State of Alaska
Department of Fish and Game
Habitat and Restoration Division

Nomination for Waters
Important to Anadromous Fish

Region SOUTHEAST USGS Quad Craig C-4
 Anadromous Water Catalog Number of Waterway 103-60-10470-2042-3012-4013
 Name of Waterway Camper Creek USGS Name Local Name
 Addition Deletion Correction Backup Information

Nomination # 01 044
 Revision Year: 2001
 Revision to: Atlas _____ Catalog _____
 Both X
 Revision Code: D-1
 Regional Supervisor: Jonda Sheffer Anderson Date: 1-26-01
 AWC Project Biologist: Ed Wein Date: 12/19/01
 Drafted: J. Stone Date: 1/14/02

CRAIG (C-4), ALASKA
 55133-E1-TF-063

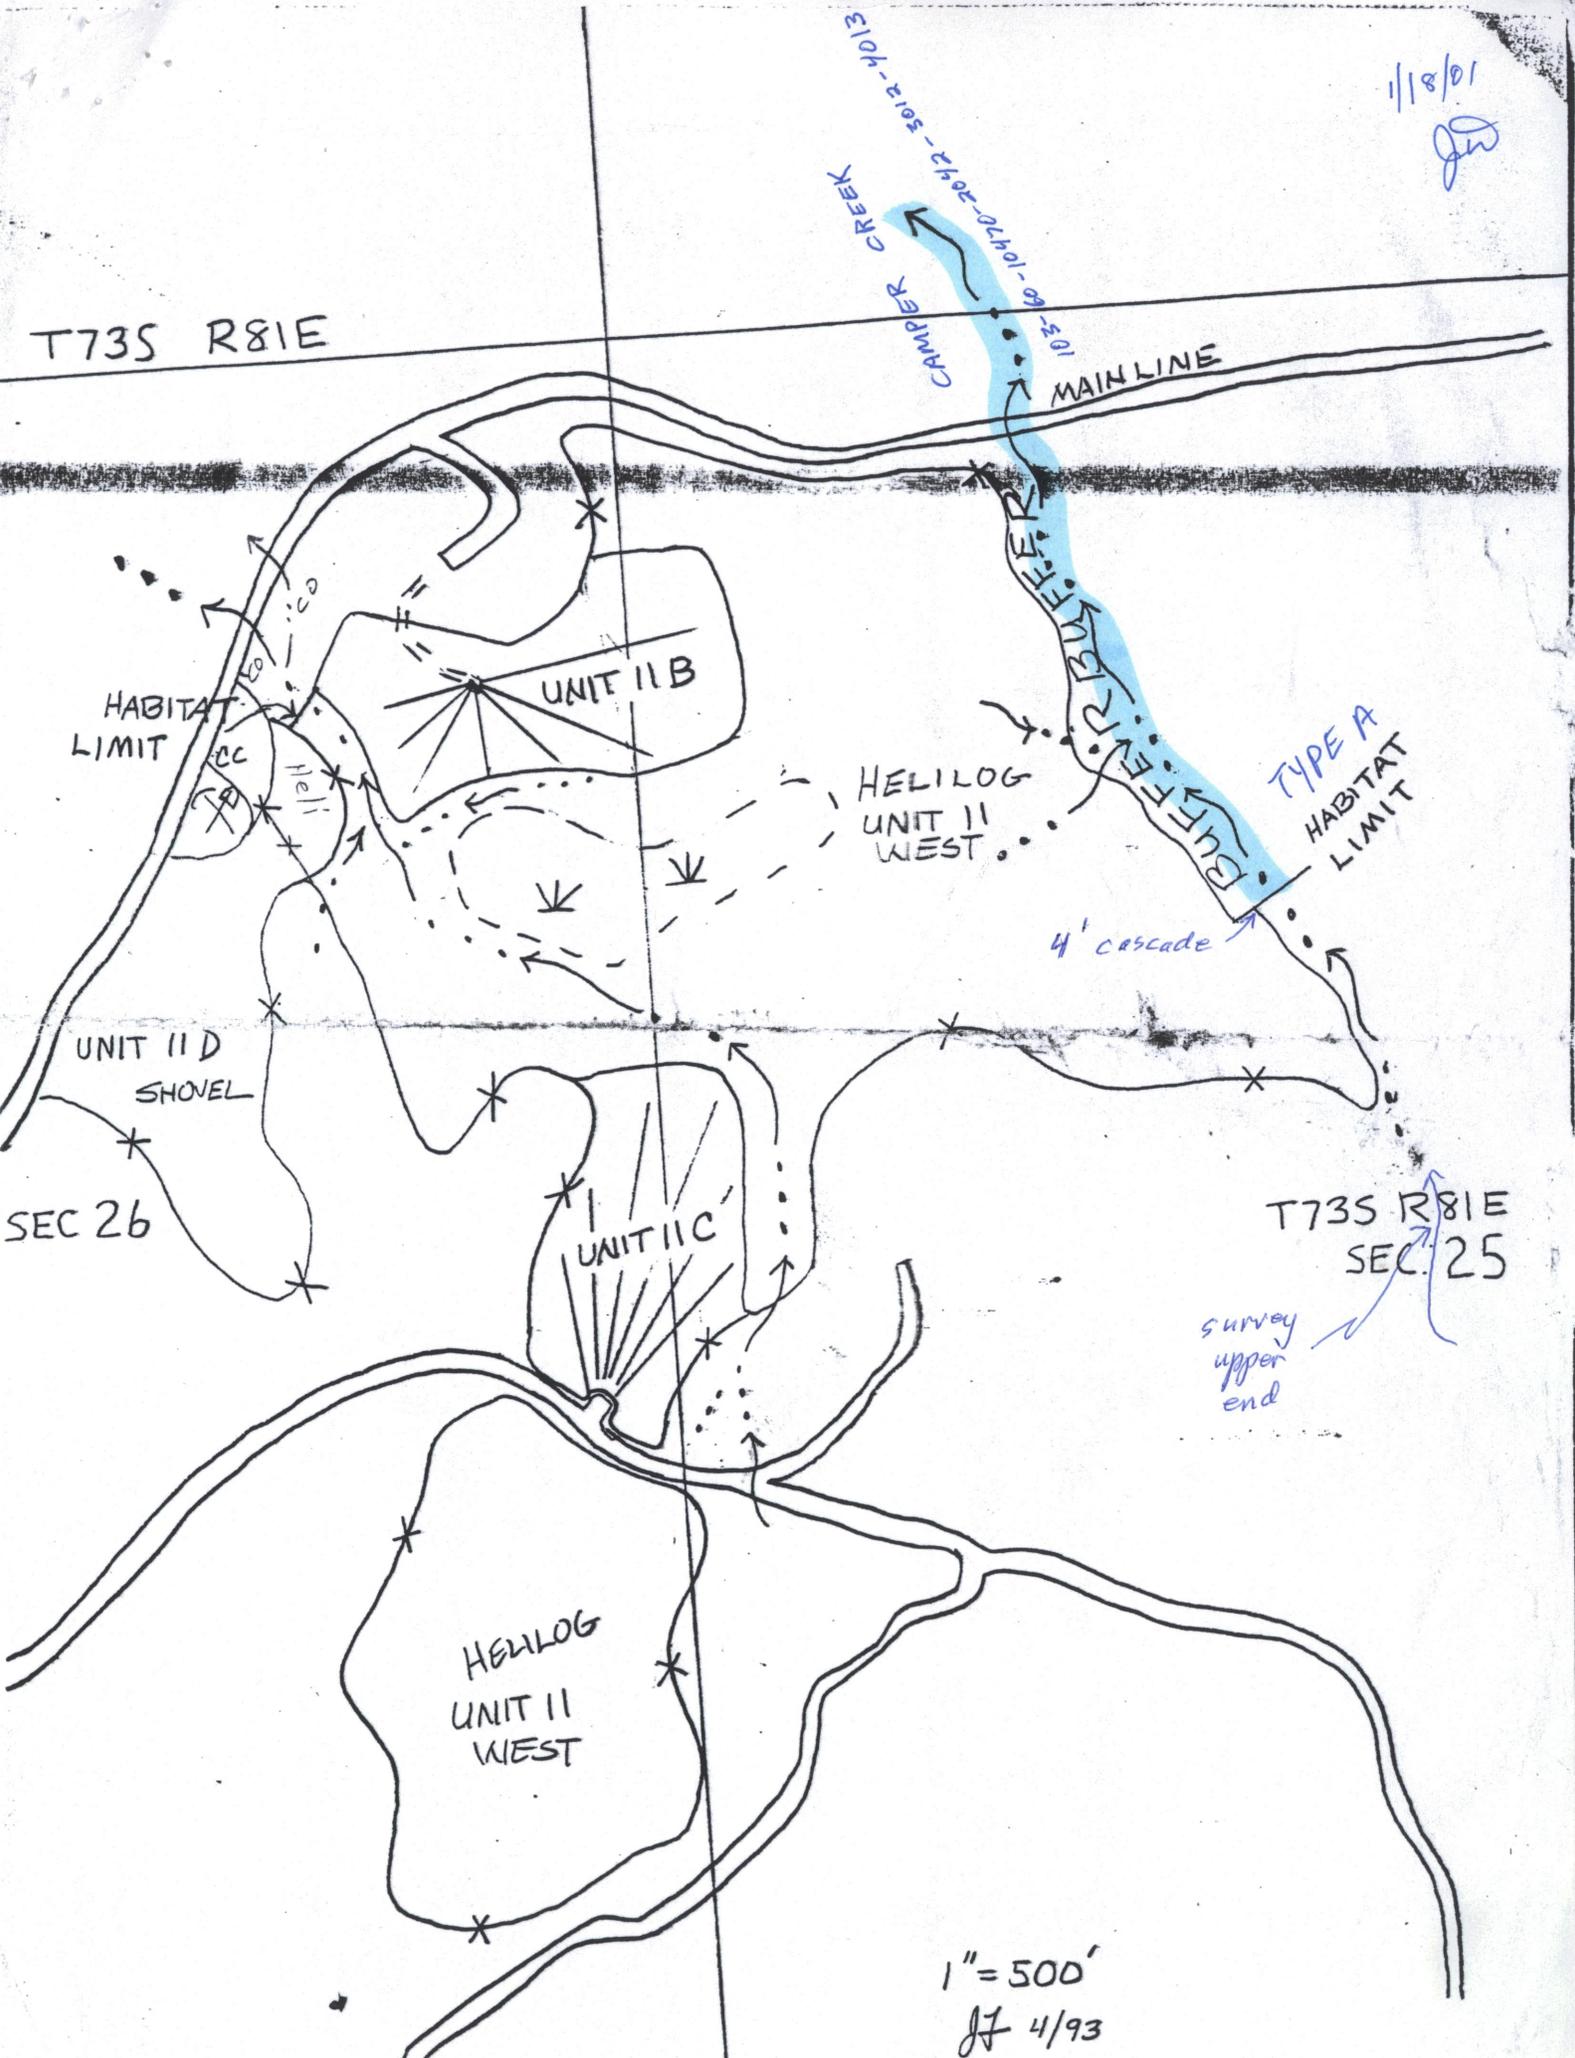
Comments: I examined a portion of this stream, designated Camper Creek, during two Forest Practices Inspections in 1993 to determine extent of anadromous fish habitat under the FRPA, and documented coho salmon juveniles above the mainline road. The upper extent of fish habitat shown in the Atlas is too far south, based on lack of evidence of anadromous fish (no bones and no captures with baited minnow traps) above a 4-foot high cascade despite apparently good quality habitat for a few hundred feet before the gradient becomes too high (> 10%). See attached maps for upper extent of Type A habitat (less than or equal to 8% gradient with evidence of anadromous fish) during the harvest period in the mid-1990s, and delete upper end in Atlas as shown. Add local name to catalog.

TYPE A HABITAT LIMIT

4' cascade

survey upper end
